GUAM POWER AUTHORITY

AMENDMENT NO.: II

INVITATION FOR BID NO.: GPA-057-19

MOBILE DIESEL STANDBY GENERATOR WITH TRAILER

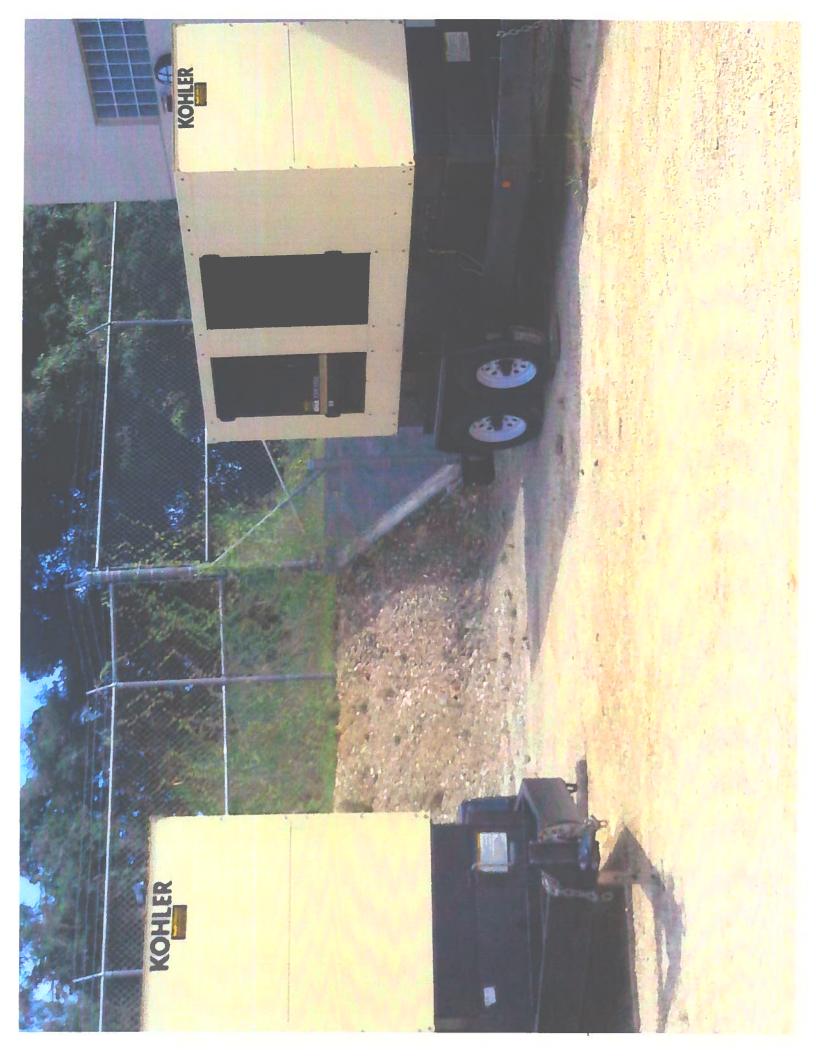
E) Please confirm this bid is only for supply of Generator with trailer only. Please send sample pictures of generator with trailer for small and large units.

This is a portable generator mounted on a trailer with wheels that can be hauled around. (see attached sample pictures).
